### New Service Housing Assembly for all Drum Brake 3030L Spring Brakes

L55335W US Rev 3/11 WEB ONLY

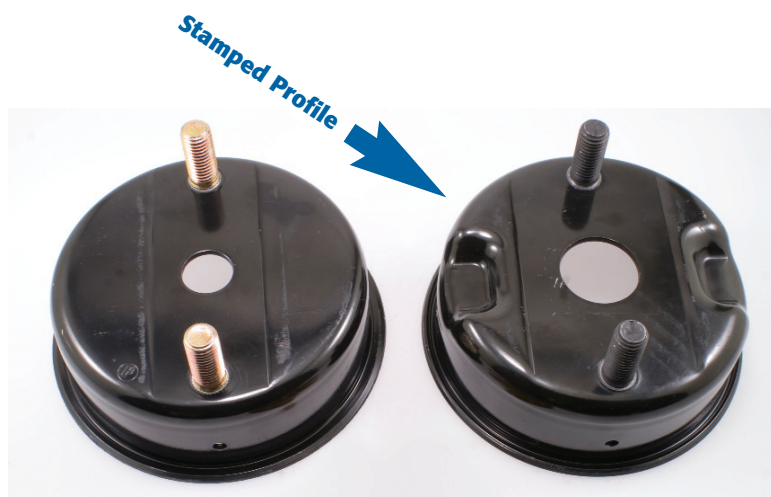
Starting in January 2011 all 76mm stroke Anchorlok® spring brakes will have a new stronger service housing. Part numbers that are affected by this change are shown in the table. The new service housing is thicker and has a distinctive stamped profile to increase rigidity. The new housing provides over 40% greater durability than the original product.

Original, flat bottom housing 3.43mm (.135 in) thickness

New thicker shaped housing 3.88mm (.149 in) thickness

Please review your application with the product change to ensure all performance and safety requirements are met.
